CORRECTION
 SERVICE FLASH

PRODUCTION CHANGE
 ADD INFORMATION

Category: **COLORTELEVISION**

Model: **DP15647**

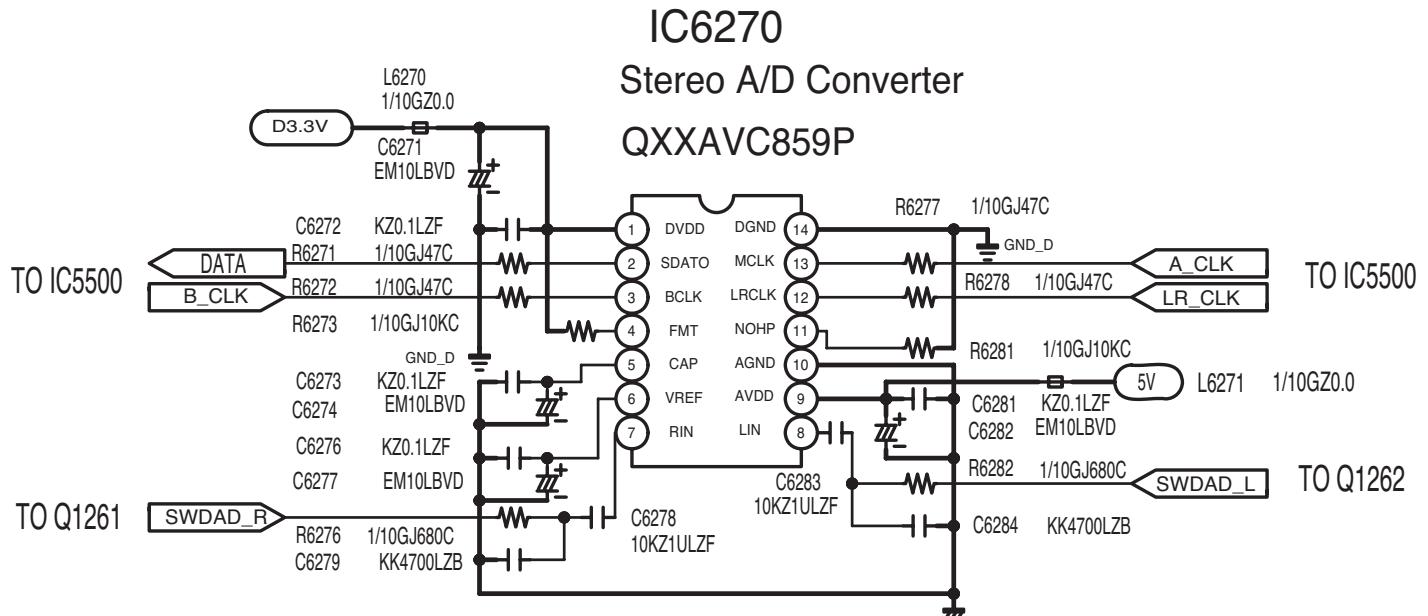
Page & Section	Schematic Location		Part No.	Description	Q'ty	Interchangeability	Reason
Page 21 Chassis Electrical Parts List	R1263	Old	RGFR000ZTCANL	MT-GLAZE 0.000 JA 1/10W	1	NO	D
		New	RGF1001JTCANL	MT-GLAZE 1K JA 1/10W	1	NO	
	R1266	Old	RGF2201JTCANL	MT-GLAZE 2.2K JA 1/10W	1	NO	D
		New	RGF1001JTCANL	MT-GLAZE 1K JA 1/10W	1	NO	
	R1269	Old	RGFR000ZTCANL	MT-GLAZE 0.000 JA 1/10W	1	NO	D
		New	RGF1001JTCANL	MT-GLAZE1K JA 1/10W	1	NO	
	R1271	Old	RGF2201JTCANL	MT-GLAZE 2.2K JA 1/10W	1	NO	D
		New	RGF1001JTCANL	MT-GLAZE 1K JA 1/10W	1	NO	
Page 22 Chassis Electrical Parts List	R1856	Old	N/A	NOT USED	0	NO	D
		New	RGF4702JTCANL	MT-GLAZE 47K JA 1/10W	1	NO	
	R1857	Old	RGFR000ZTCANL	MT-GLAZE 0.000 JA 1/10W	1	NO	D
		New	NA	NOT USED	0	NO	
	R1858	Old	N/A	NOT USED	0	NO	D
		New	RGF4702JTCANL	MT-GLAZE 47K JA 1/10W	1	NO	
	R1859	Old	RGFR000ZTCANL	MT-GLAZE 0.000 JA 1/10W	1	NO	D
		New	NA	NOT USED	0	NO	
Page 24 Chassis Electrical Parts List	A001	Old	1AA0B10N222F0	ASSY, PWB, MAIN	1	NO	D

New	1AA0B10N222H0	ASSY, PWB, MAIN	1	NO	
	△EL901	Old	1AV4T40B83400	LCD (CLAA150XP03)	1	NO	D
		New	1AV4T40B84200	LCD (CLAA150XP01Q)	1	NO	
	△U901	Old	1AV4U20C09100	UNIT, INVERTER-POWER	1	NO	D
		New	1AV4U20C11100	UNIT, INVERTER-POWER	1	NO
